11/20/2019 WATERSHED SUBMITTAL

CASE FILE #PL201900220

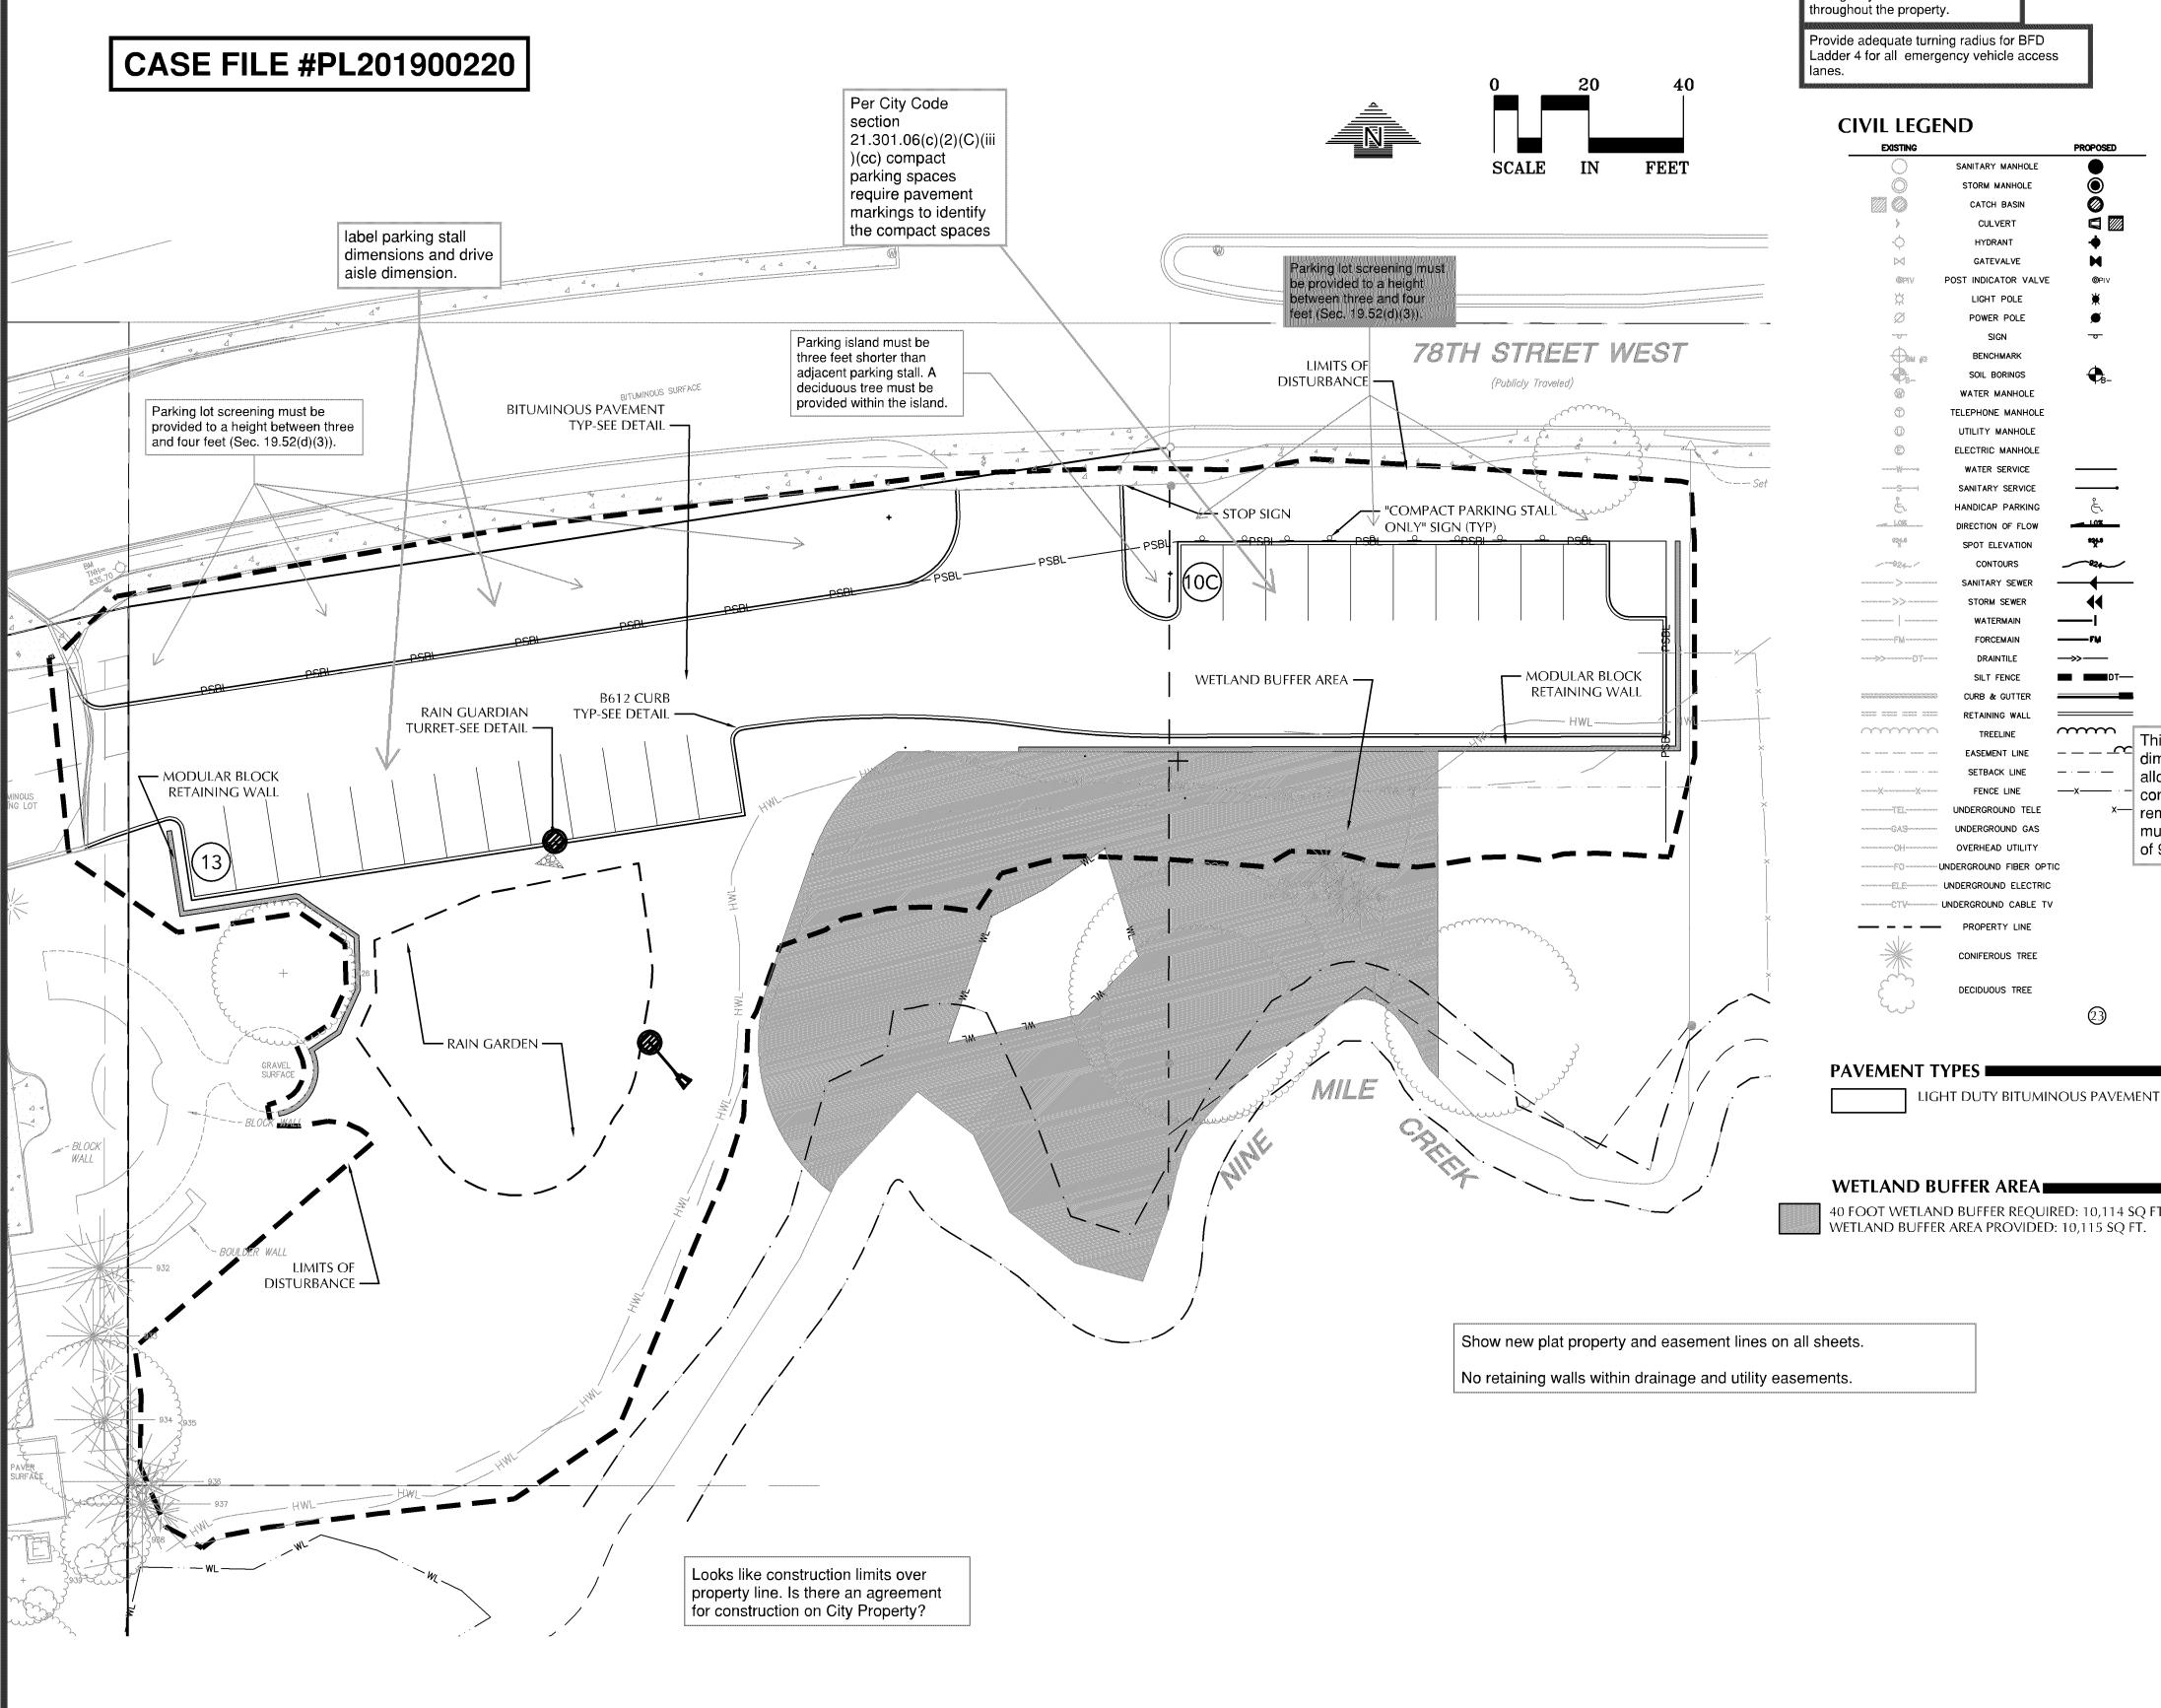
Looks like construction limits over property line. Is there an agreement for construction on City Property?

Provide for the new parking area and maintain for existing structures emergency vehicle access

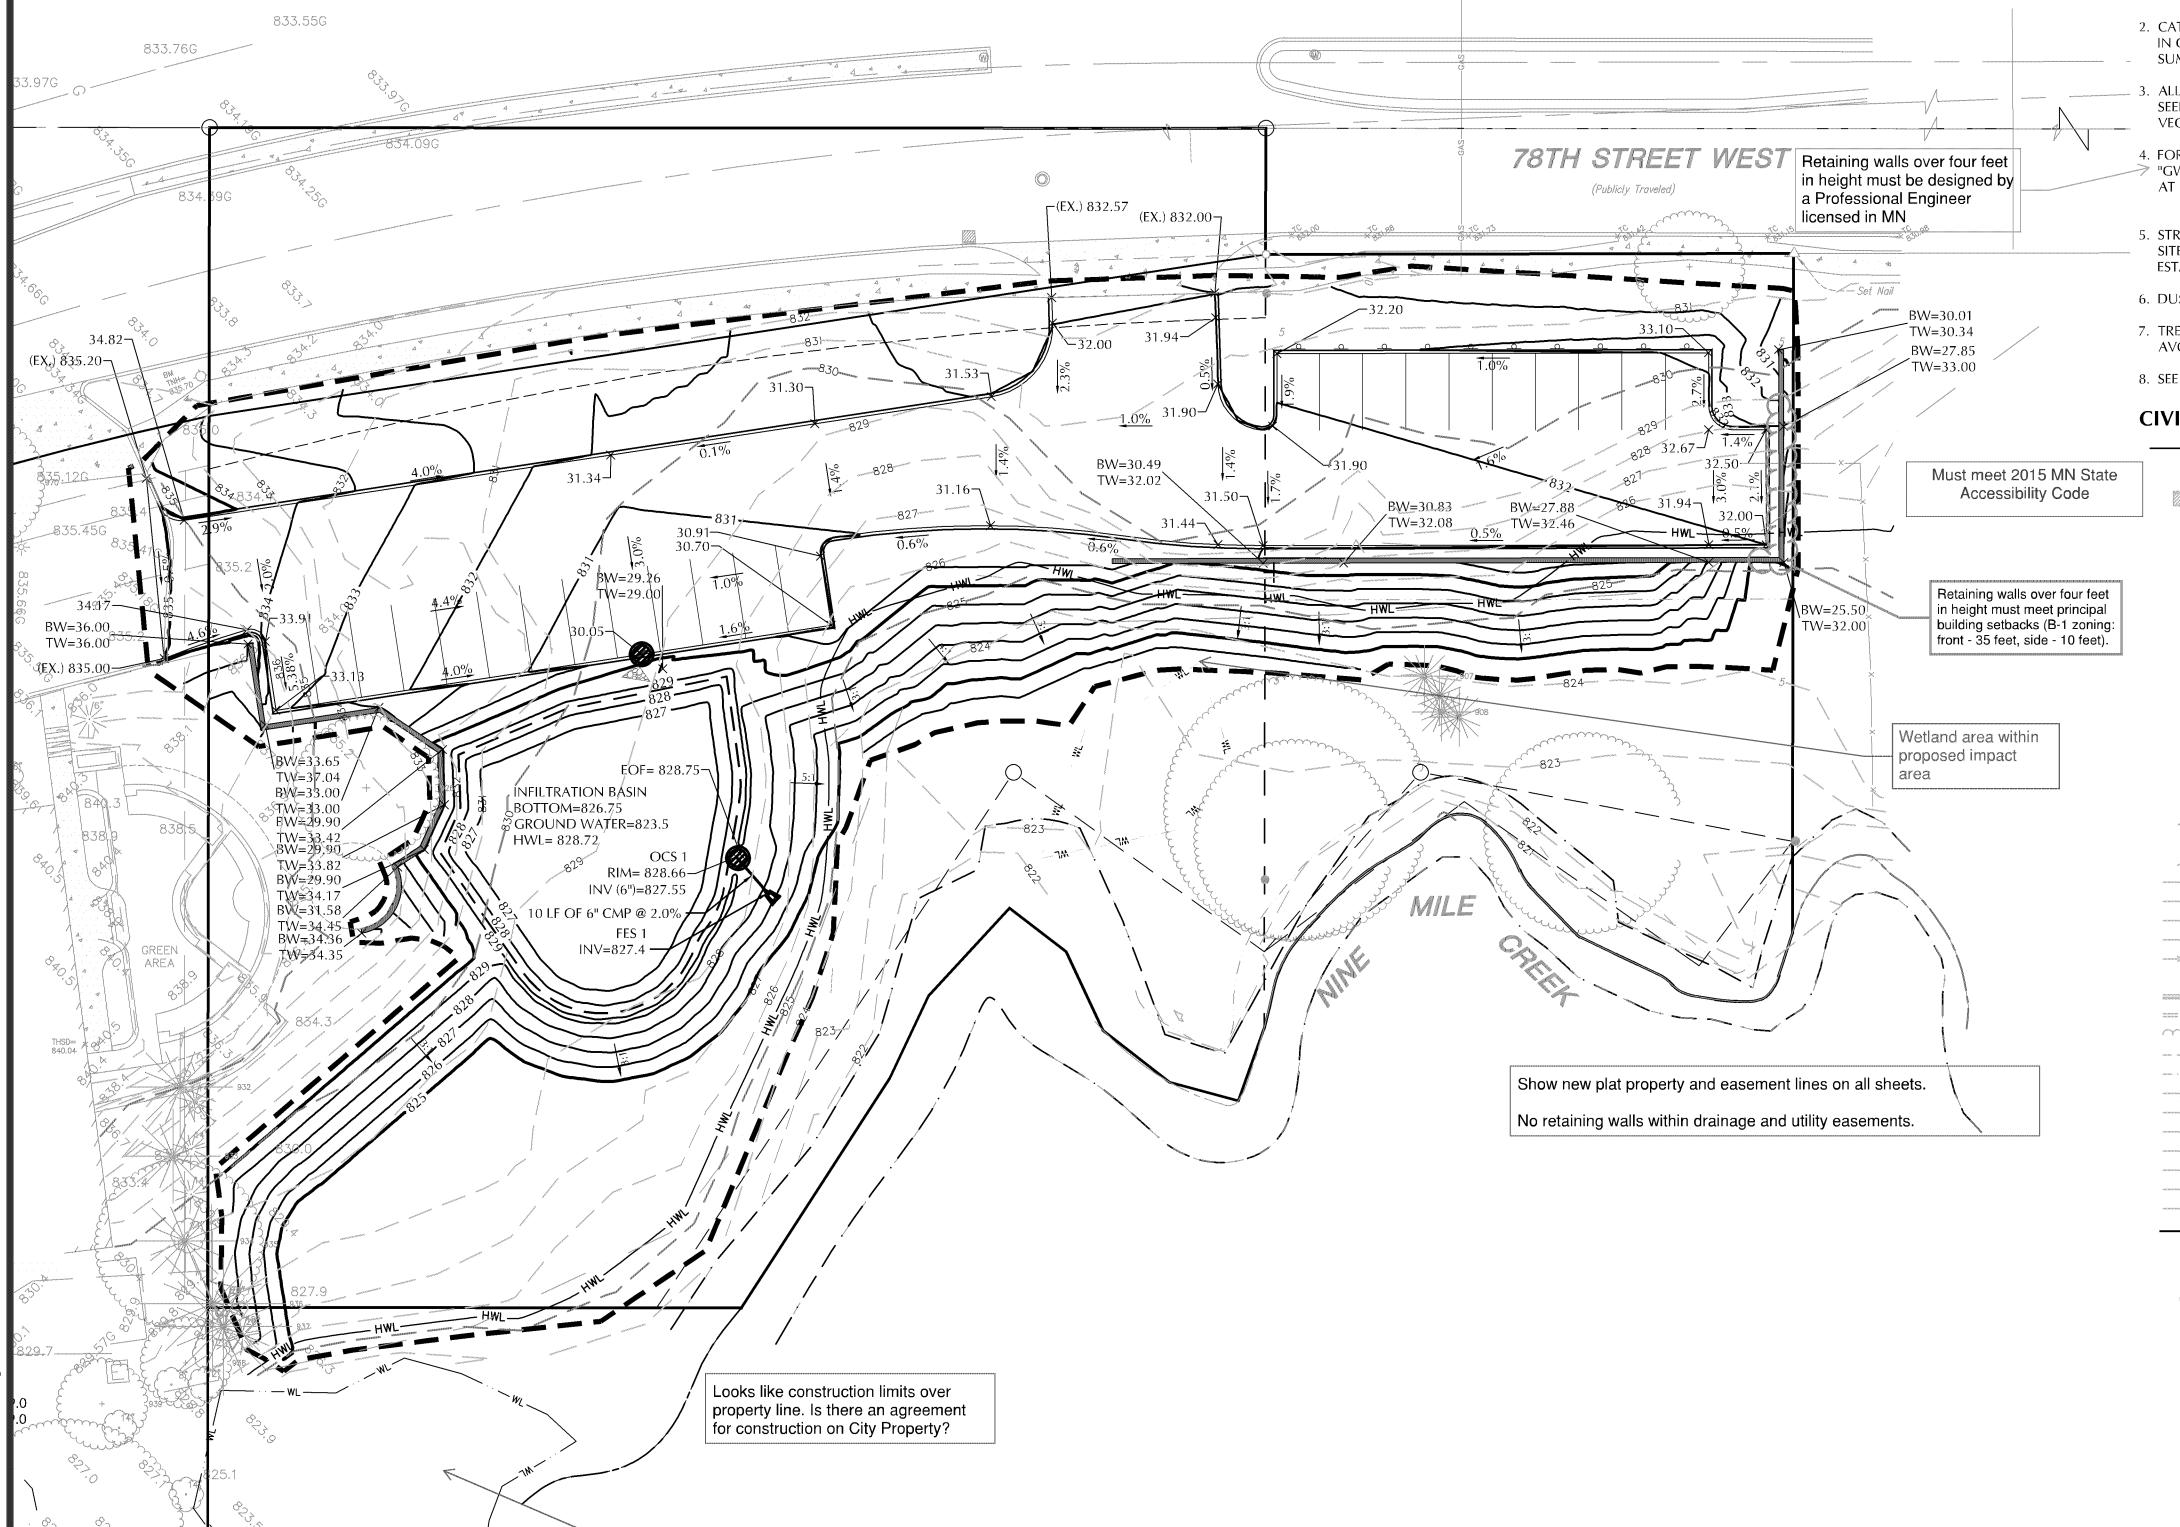
nis parking stall mension is only lowable in the compact spaces, the x— remaining spaces

must be a minimum

of 9' by 18'

No signs or pavement markings allowed in the public right-of-way, place behind the property

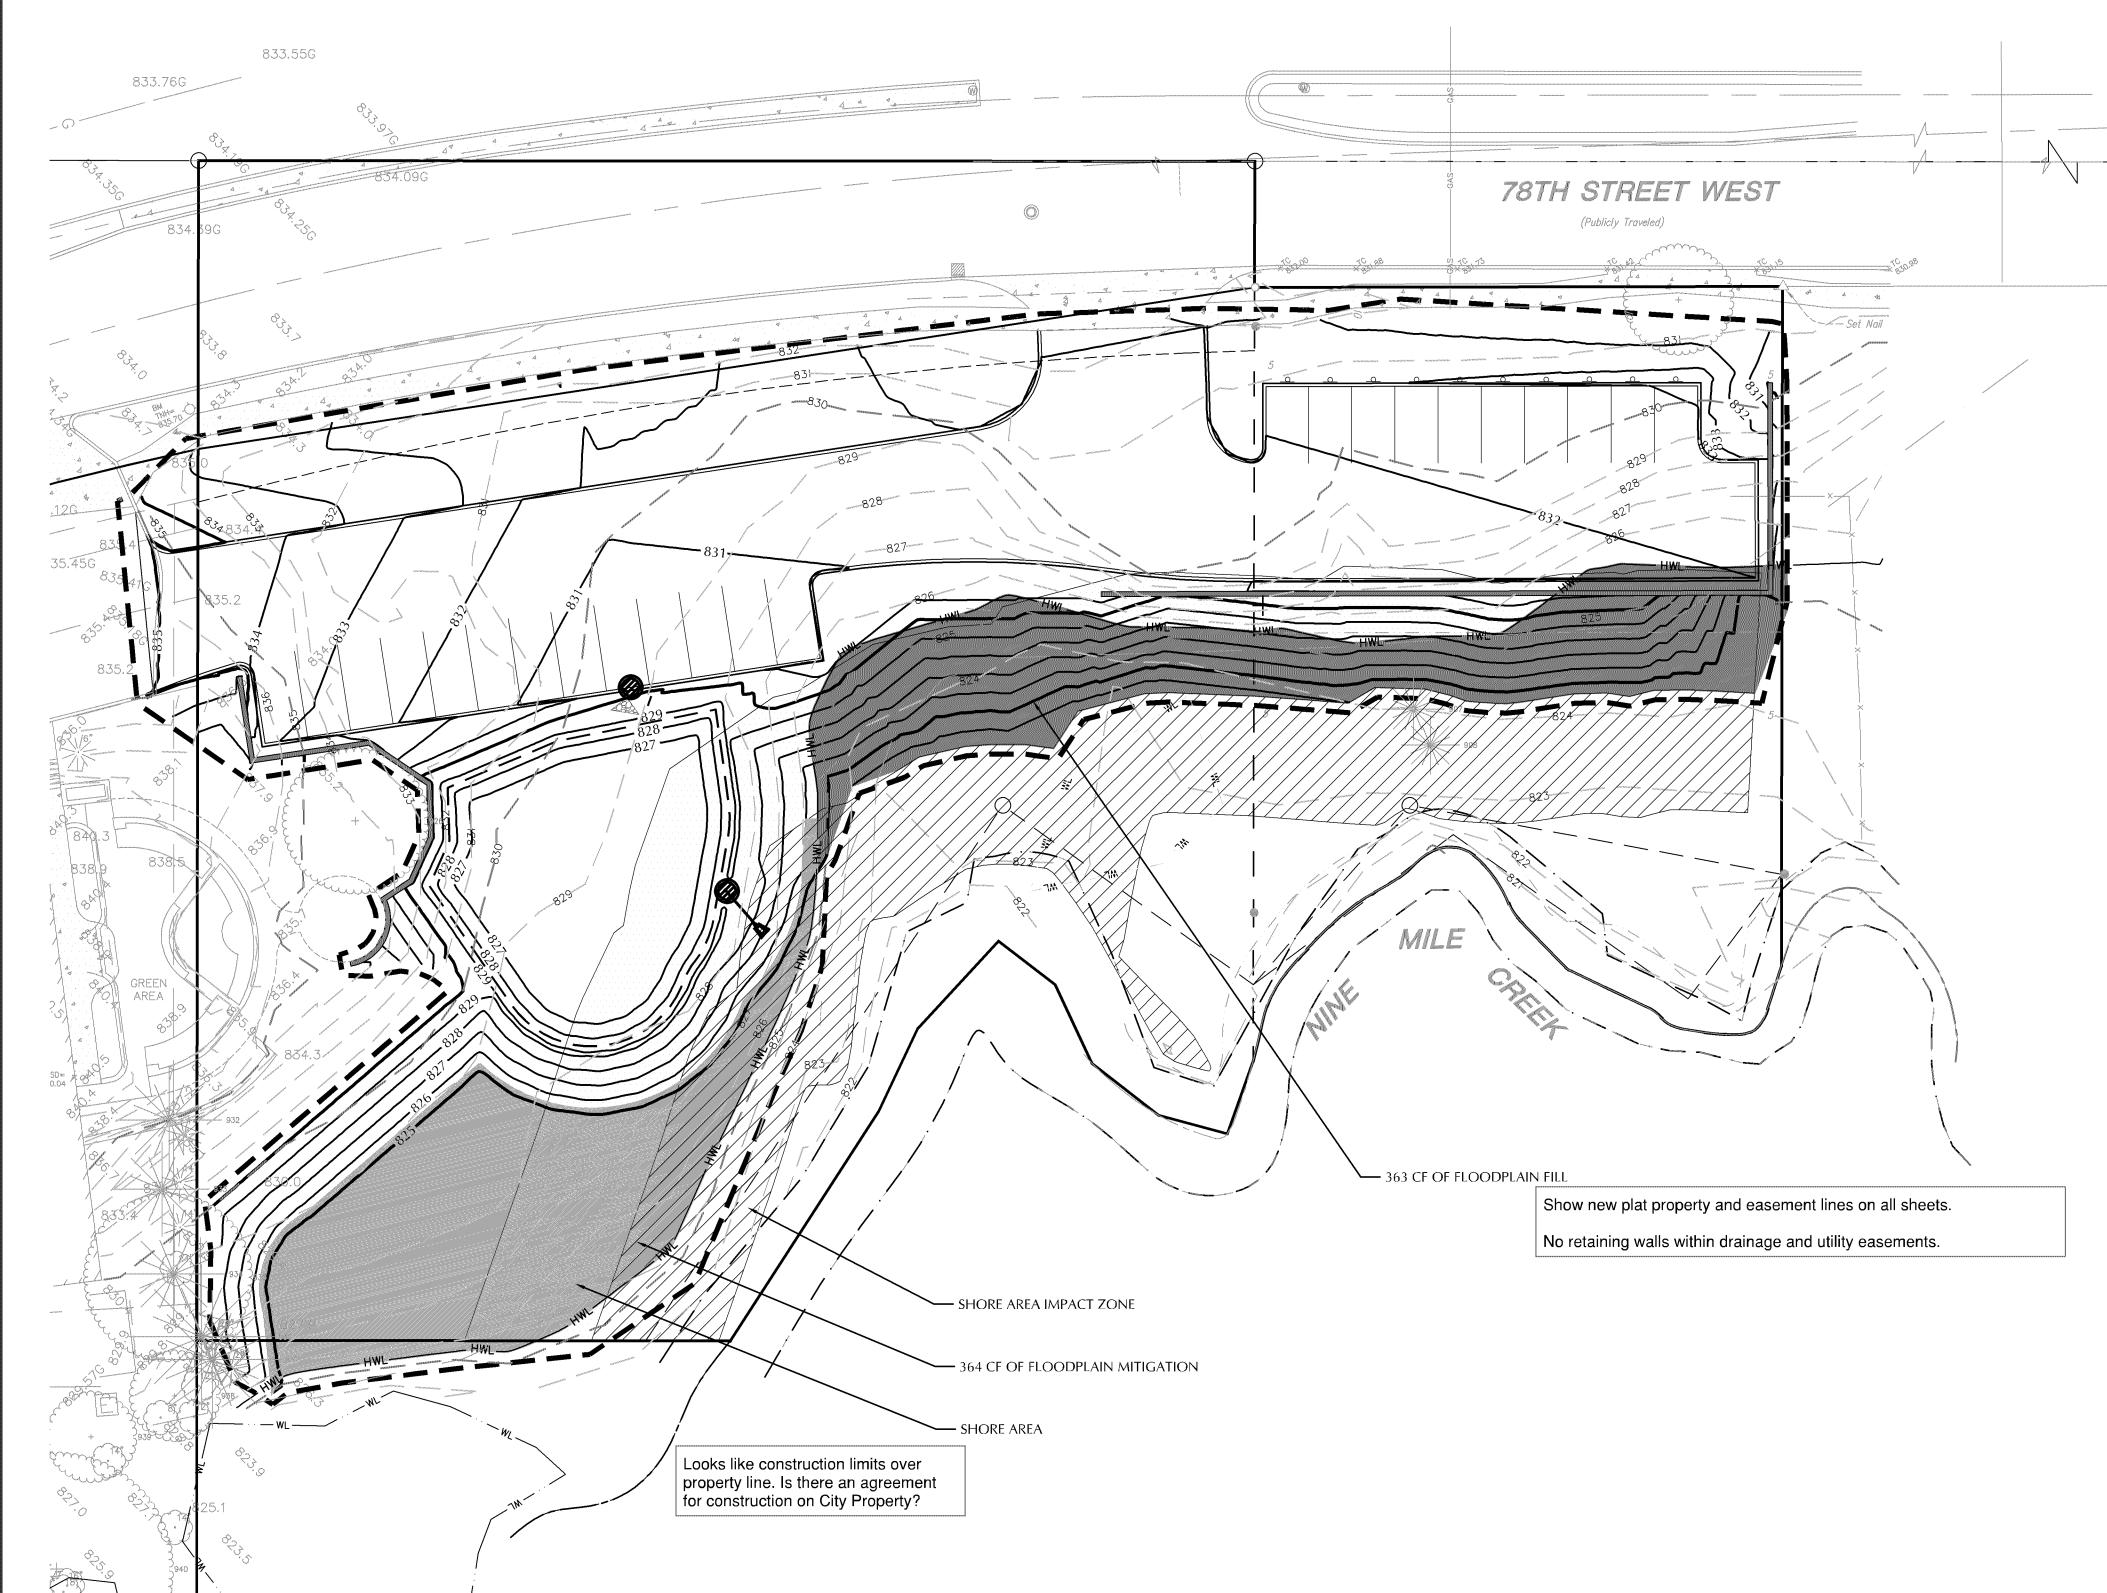
Label wetland areas consistent with

delineation report
